# Modifications and Improvements for LCLS-II ProdCMs

Tug Arkan on behalf of the Fermilab LCLS-II team

## 1.3 GHz Production Cryomodule, F10041183, 3D model

CM02 configuration

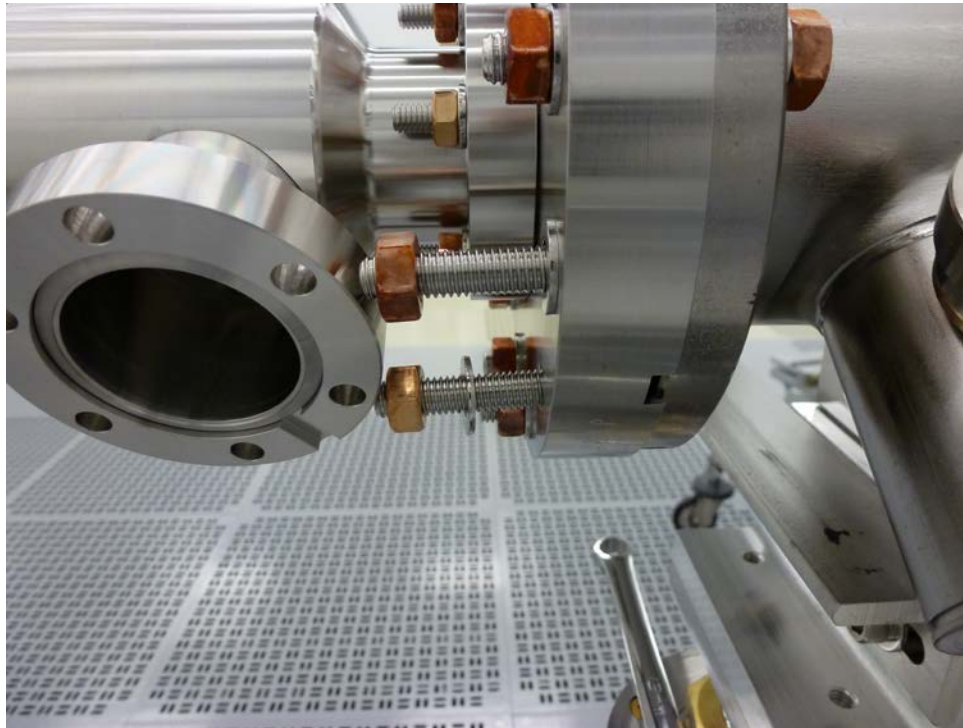
CM02 cavities FPC end beampipe flange right angle valve orientation caused deviation from standard PFFA assemblies. This is resolved for CM03 cavities.

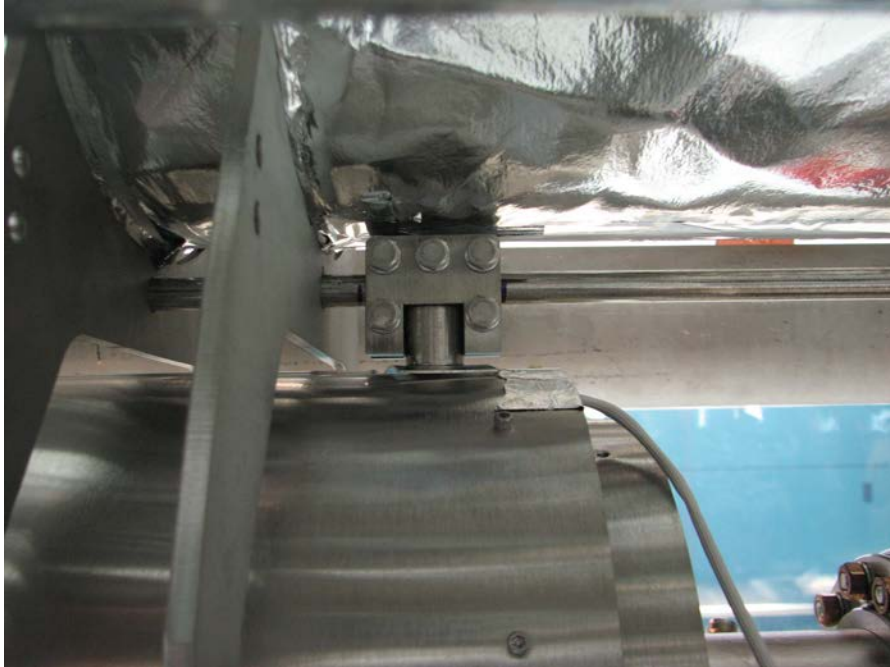
magnetic shielding had mechanical interfaces (specifically tuner range is reduced). This was due to increased tuner range after magnetic shielding end caps were fabricated	magnetic shielding design is optimized to eliminate mechanical interferences.	magnetic shielding design is optimized to eliminate mechanical interferences
	Cavity heaters attached with epoxy & string	Cavity heaters attached with epoxy & welded Ti wrap	Cavity heaters attached with epoxy & welded Ti wrap

Standard cavity to invar rod clamp for pCM

Reinforced clamp design for Cav#1 and Magnet for ProdCMs

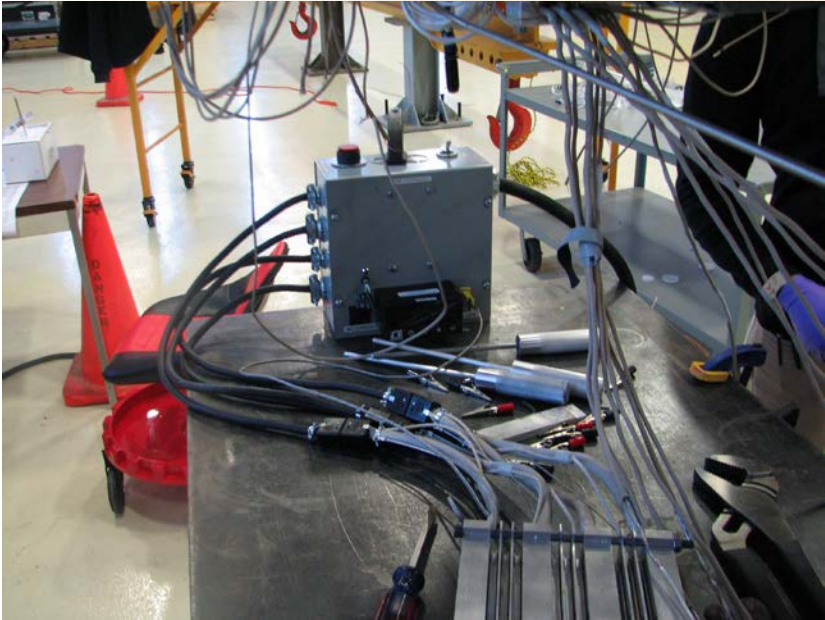
- Change in configuration for thermal connection from power couplers to 50K.
- 5K coupler intercept modified to hold vacuum forces.

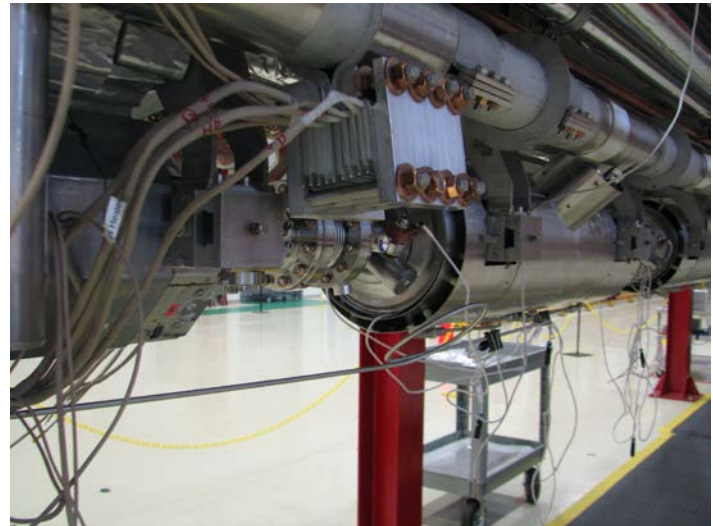
Split quad current leads cooling flaps soldering is done with a fixture to solder multiple leads simultaneously with an automated process for faster, more reliable and less risky procedure

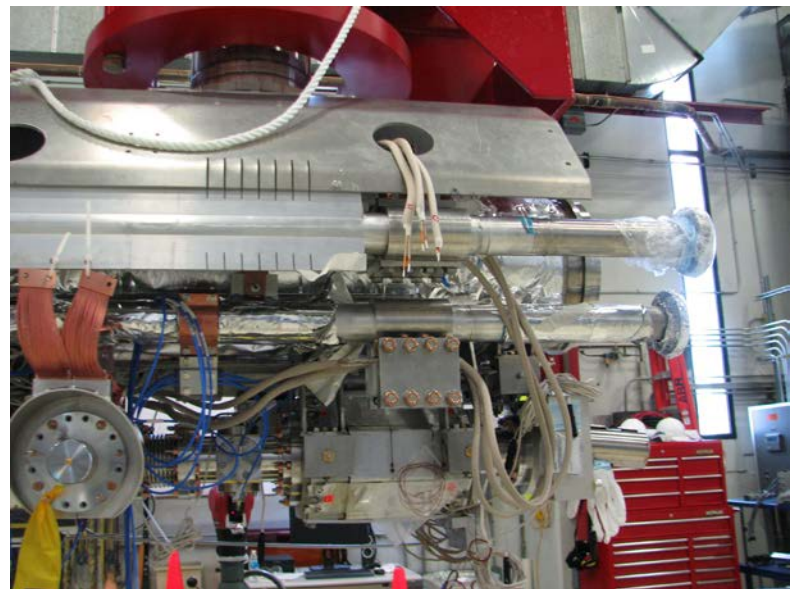
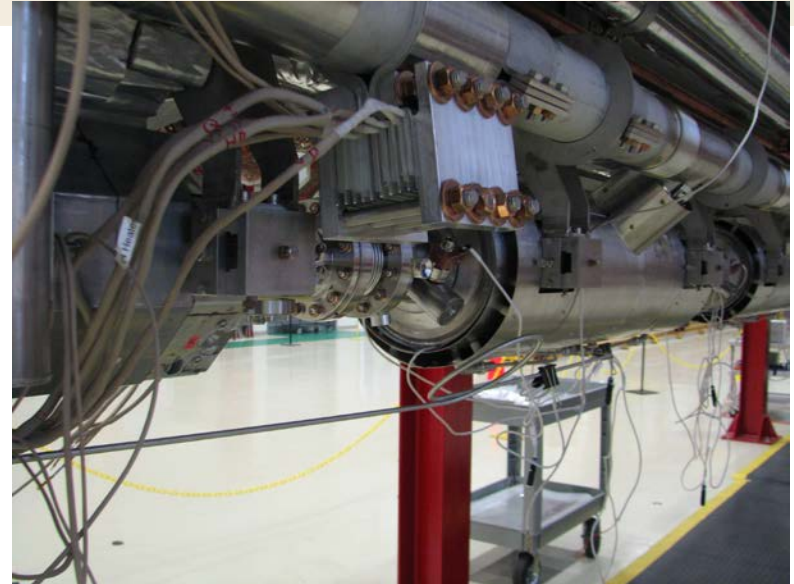
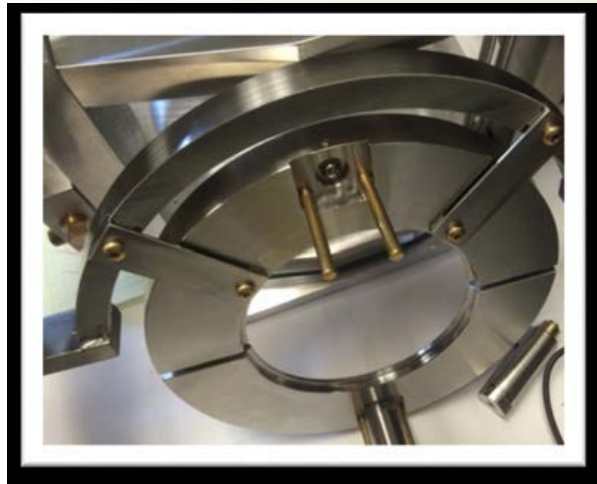
According to the latest calculations done and results from pCM:

- for 25 A the length of #18 copper leads between 5K and 50K intercepts shall be trimmed to 23" (was 34") and the length of #12 copper leads between 50K and 300K intercepts shall be trimmed to 20" (was 26.575")
  - if this length allows soldering leads to the 300K flange (20" might be too short for this), in this case we shall trim these leads as much as we can).
- The SC magnet leads soldered to the #12 copper wire between 2K and 5K shall be kept as long as possible to reduce the heat flow from 5K to 2K intercept (for pCM, we trimmed them by ~15").

Modified split ring with set screws

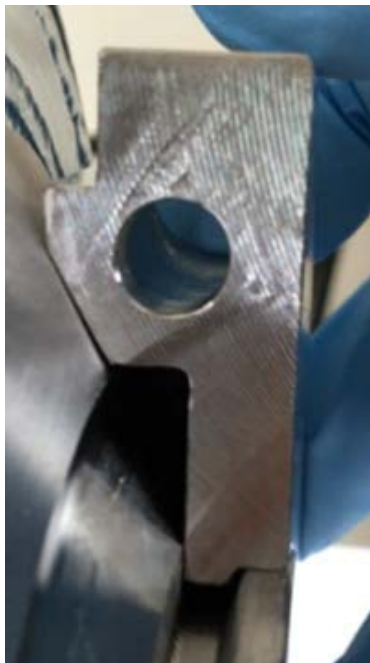
Split Ring need to be mount on the cavity between Nb alignment ring and NbTi conical flange close-fitting

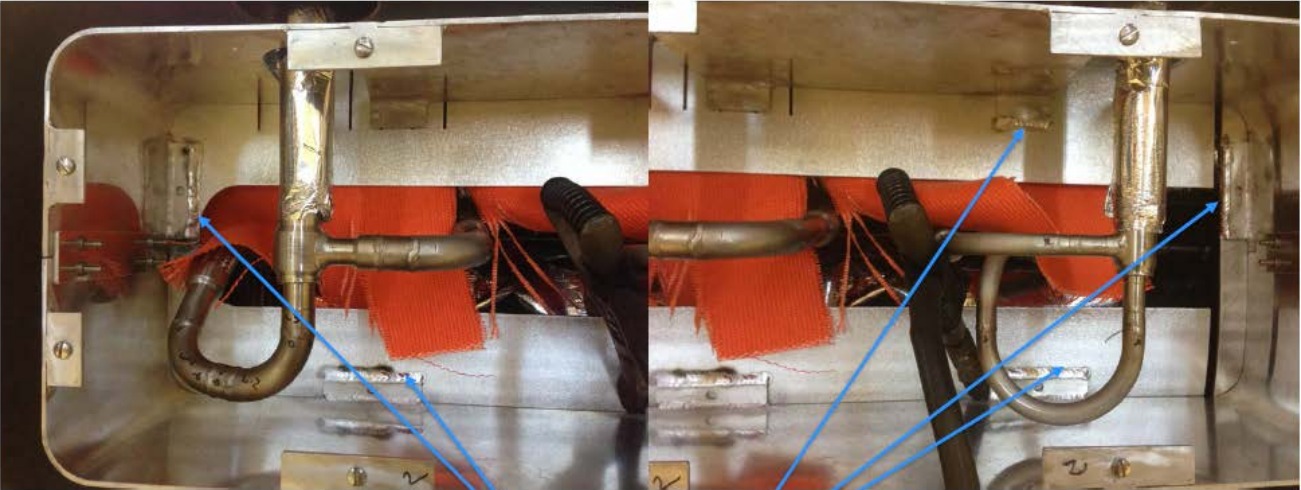
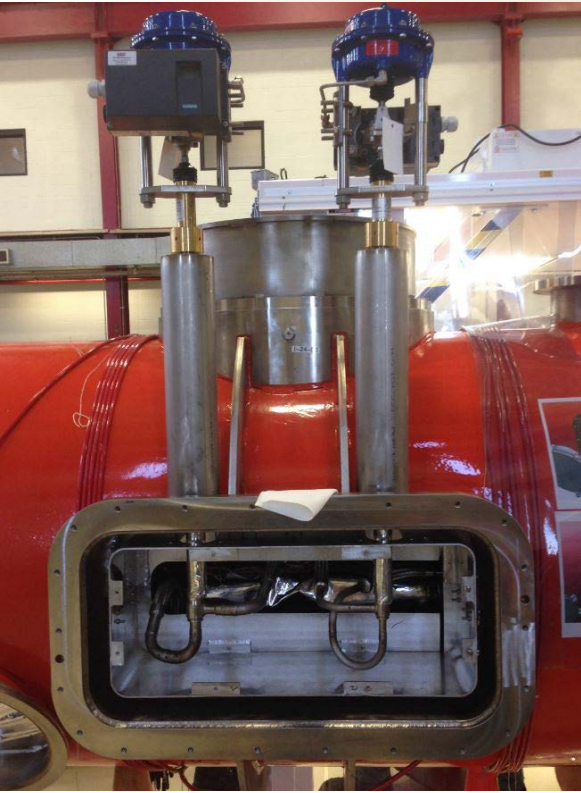
- Instrumentation flanges (reduced connectors, reduced size of guard helium flange)
- Magnet current lead flange cover for better protection of the fragile leads

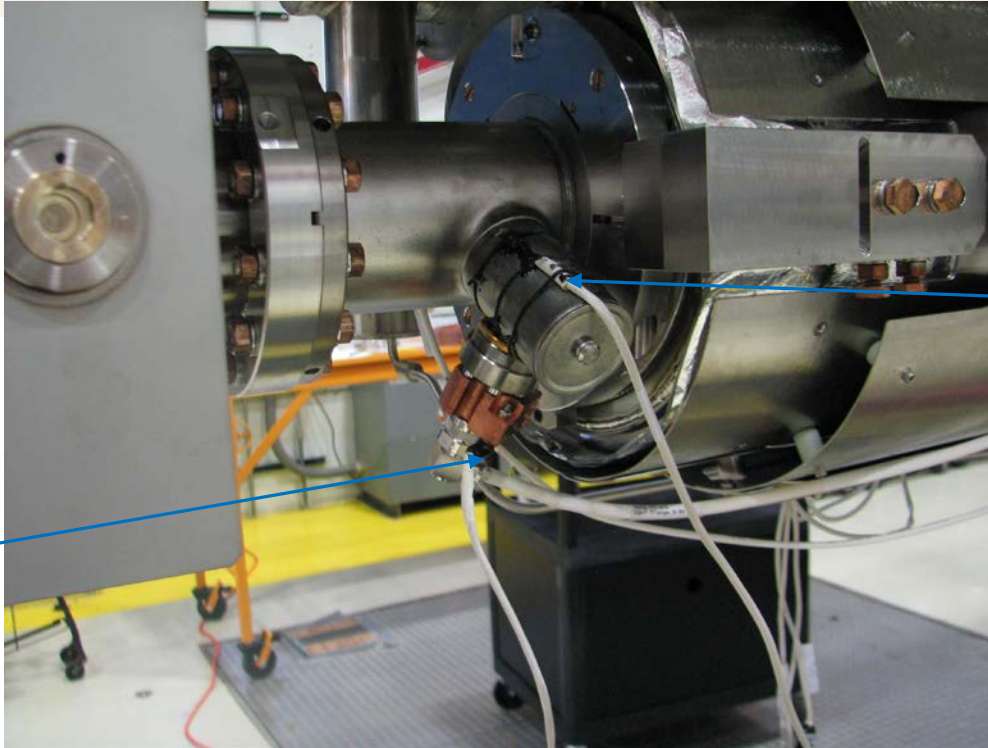
- Reduced amount from pCM to ProdCMs
- For CM02, we have added back the 16 diode sensors for HOM bodies based on the current tests done on pCM. The end of the extended tests done on pCM shall be the decision point if we need to install these sensors for all ProdCMs.
- Helium vessel sensors on pCM is reading magnetic shielding temp. We believe that magnetic shielding is pressing to the helium vessel sensors through the 10 layers MLI. Starting from CM03, we will cut a hole of the MLI to stop the thermal path and also we are considering a G10 stand-off insulator to be installed on top of the diode sensors so it does not cross talk with the magnetic shielding.

Helium Vessel Diode Sensor (top & bottom)

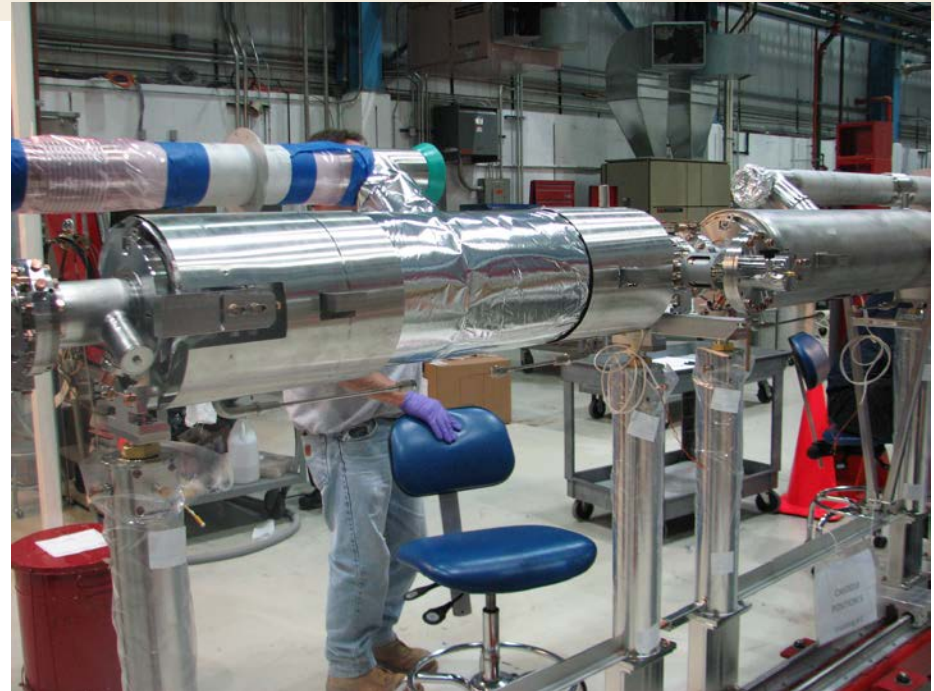
- all 8 cavities for pCM
- Cav#1 and Cav#5 for ProdCM

These diode sensors on pCM are reading magnetic shielding temp rather than helium vessel. Starting from CM03, thermal path between the installed sensor and magnetic shielding will be eliminated

# Vibration sensitive items mitigation on CM02

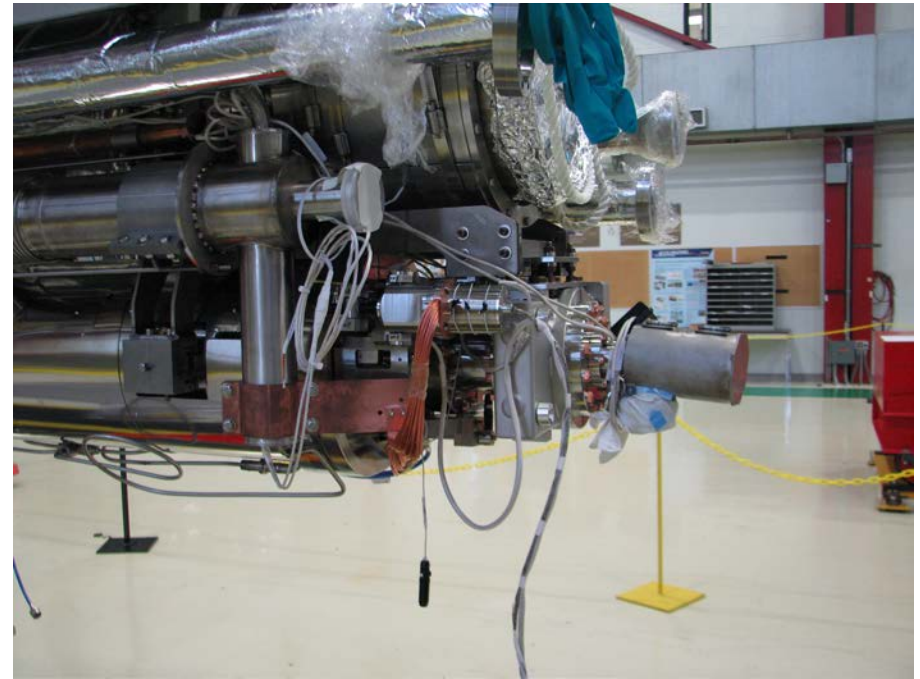
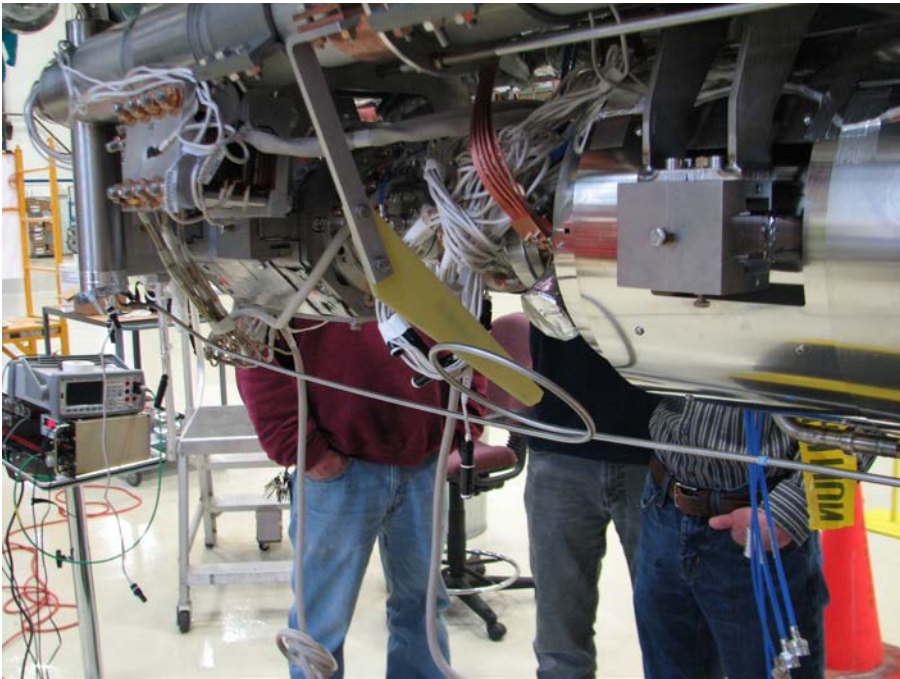
1. Support the capillary line from upstream end liquid level probe to cavity#1
2. Complete the assembly on the tuners and 2-phase pipe invar rods clamps and after the assembly resonance group will measure and if needed we will add G-10 supports around the 2-phase for these long invar rods.

3. Design group started to work on the design and drawings for a larger diameter JT fill line. CM assembly started to think about the least obstructive way to cut the current pipe and weld the larger diameter pipe.

4. Resonance group will continue to work with CMTS folks to further analyze the data from pCM and before we weld the lower heat shields, we will have another meeting to decide if we proceed with CM02 assembly or do further modifications based on the new results.

5. Setup a stand alone cavity under a cold mass upper at Cav#1 position. Assemble with upstream end gate valve and extra weight assembled top the gate valve to simulate BLA. Conduct vibration analysis tests.

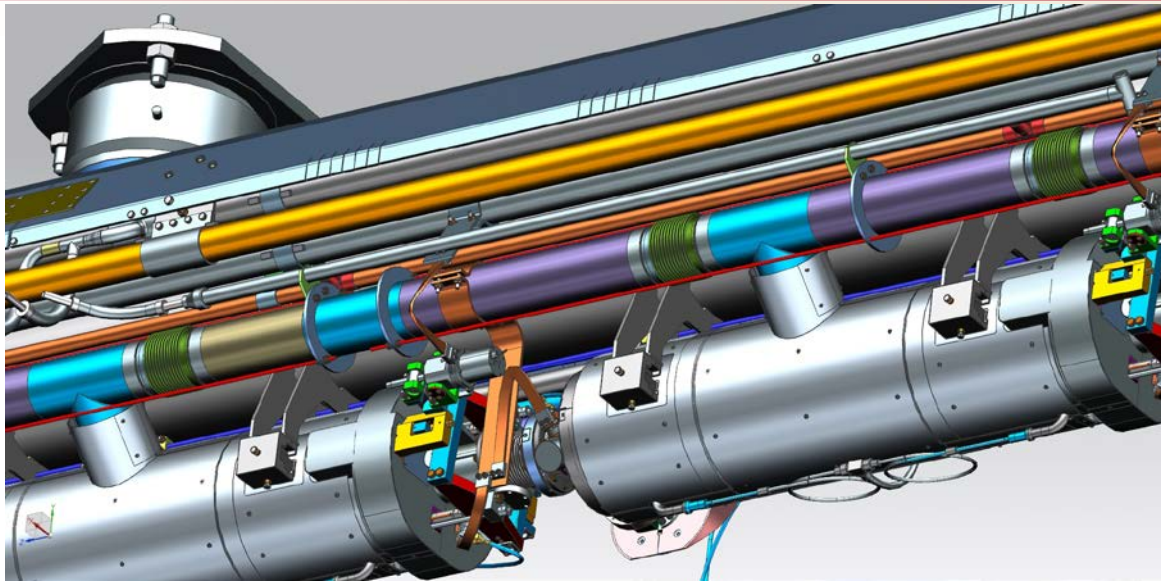
Downstream liquid level probe housing to Cav#8 capillary line is supported in pCM and CM02. For CM02, install similar support between Cav#1 and upstream liquid level probe housing

This line size was just originally selected based on mechanical space constraints and a desire for flexibility. We were not concerned about pressure drop. Our main consideration for 2-phase flow management was separation of that inlet location from the exit to the 300 mm pipe, so as not to carry liquid up into the HGRP.

For CM02, we are planning to replace this line with a larger diameter from 0.5 to 1 inch
